Access Compliance Report

Public Rights-of-Way

(Pedestrian Signals)

Intersection ID: N/A	Main Street:	Cross Street: N/A	Location: N/A
ADA ID: 128CDD225236	Signal Type: One Push Button-Non APS	Overall Compliance: No	Severity Score: BTN 1: N/A BTN 2: N/A No BTN: N/A
Codes/Mitigation Info/Possible Solution		Field Measurements/Component Compliance

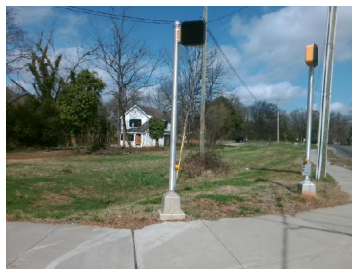
PROW/ADA: , TMUTCD 4e.08, R404.2, R404.3, R404.7.2

Compliance	Description	Data	Compliance	Description	Data
	Button Count	Button1	No	Distant to Additional Button (in)	116.0
	Additional Button Present?	Yes		Additional Button ID	D7DCA6FC1305
N/A	Signal Buttons Required?	N/A	N/A	Additional Ped Posts Required	N/A
	How Many Ped Street Xings?	N/A		Located In An Island/Median?	N/A
N/A	B 1 Sign Present?	Yes	N/A	B 2 Sign Present?	N/A
Yes	B 1 Sign Purpose?	Yes	N/A	B 2 Sign Purpose?	N/A
Yes	B 1 Sign Lettering & Contrast?	Yes	N/A	B 2 Sign Lettering & Contrast?	N/A
Yes	B 1 Parallel To XWalk?	Yes	N/A	B 2 Parallel To XWalk?	N/A
Yes	B 1 PAR to Button?	Yes	N/A	B 2 PAR to Button?	N/A
Yes	B 1 PAR to XWalk?	Yes	N/A	B 2 PAR to XWalk?	N/A
Yes	B 1 Clear Floor Space?	Yes	N/A	B 2 Clear Floor Space?	N/A
N/A	B 1 FWD Approach?	No	N/A	B 2 FWD Approach?	N/A
N/A	B 1 FWD Approach Constrained?	N/A	N/A	B 2 FWD Approach Constrained?	N/A
N/A	B 1 FWD Approach Reach (in)	N/A	N/A	B 2 FWD Approach Reach (in)	N/A

N/A	B 1 FWD Approach Width (in)	N/A	N/A	B 2 FWD Approach Width (in)	N/A
N/A	B 1 FWD Approach Obstruction?	Yes	N/A	B 2 FWD Approach Obstruction?	N/A
N/A	B 1 FWD Approach Obstruction Dist (in)	5.0	N/A	B 2 FWD Approach ObstructionDist (in)	N/A
N/A	B 1 PARA Approach?	Yes	N/A	B 2 PARA Approach?	N/A
N/A	B 1 PARA Approach Constrained?	Yes	N/A	B 2 PARA Approach Constrained?	N/A
Yes	B 1 PARA Approach Reach (in)	6.0	N/A	B 2 PARA Approach Reach (in)	N/A
No	B 1 PARA Approach Width (in)	48.0	N/A	B 2 PARA Approach Width (in)	N/A
N/A	B 1 PARA Approach Obstruction?	Yes	N/A	B 2 PARA Approach Obstruction?	N/A
N/A	B 1 PARA Approach Obstruction Dist (in)	6.0	N/A	B 2 PARA Approach ObstructionDist (in)	N/A
No	B 1 Clear Floor Space Slope (%)	2.7	N/A	B 2 Clear Floor Space Slope (%)	N/A
No	B 1 Clear Floor Space XSlope (%)	3.0	N/A	B 2 Clear Floor Space XSlope (%)	N/A
N/A	B 1 PAR Slope (%)	N/A	N/A	B 2 PAR Slope (%)	N/A
Yes	B 1 Height (in)	32.0	N/A	B 2 Height (in)	N/A

N/A	B 1 Clear Xing Direction?	Yes	N/A	B 2 Clear Xing Direction?	N/A
	B 1 Crossing Direction	To SW		B 2 Crossing Direction	N/A
Yes	B 1 DistanceTo XWalk (in)	0.0	N/A	B 2 DistanceTo XWalk (in)	N/A
No	B 1 DistanceTo Curb (in)	132.0	N/A	B 2 DistanceTo Curb (in)	N/A
Yes	B 1 Diameter (in)	2.0	N/A	B 2 Diameter (in)	N/A

Possible Solutions: Replace Signal Push Button With APS Button on New Post. Remove & Relocate Sign.
